Old Mammoth Place – Concept Review

CR 15-001

Planning & Economic Development Commission
Workshop

July 30, 2015

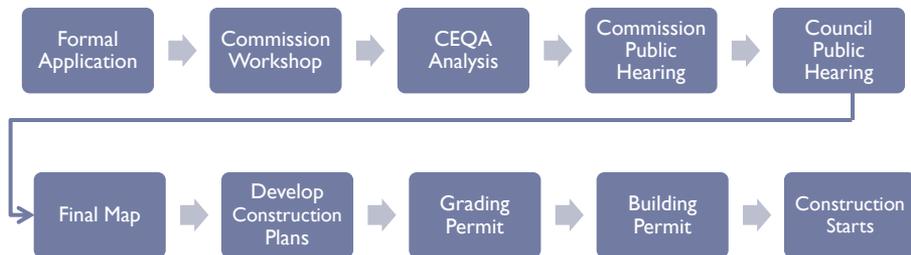
Additional information and analysis needed to determine consistency with the following:

Goal C.2: Design the man-made environment to complement, not dominate, the natural environment.

- Policy C.2.E: Ensure that each district center is an attractive destination that is comfortable and inviting with sunny streets, plazas and sidewalks.
- Policy C.2.J: Be stewards in preserving public views of surrounding mountains, ridgelines and knolls.
- Policy C.2.V: Building height, massing and scale shall complement neighboring land uses and preserve views to the surrounding mountains.

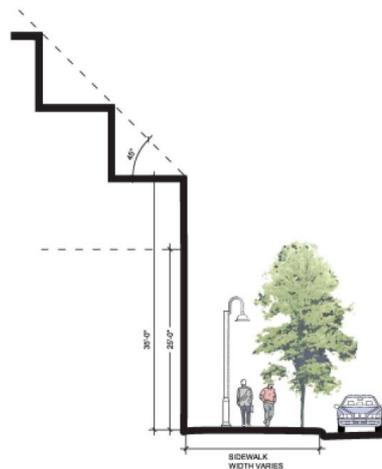
A. Based on conceptual plans, do the proposed building height requests appear reasonable?

- 10ft height increase along Laurel Mtn Rd (45ft)
- 10-20ft height increase along Old Mammoth Place (55ft)
- For reference, OMR and D Zones allow 20% of a building face along a street to be 45ft tall but exceptions can allow up to 60% at 45ft
- 10ft setback required from max building face
- 10-30ft height increase in the center of the site (65ft)
- For reference, max height is 55ft in D Zone, 45ft in OMR Zone, and 35ft in RMF-2 Zone
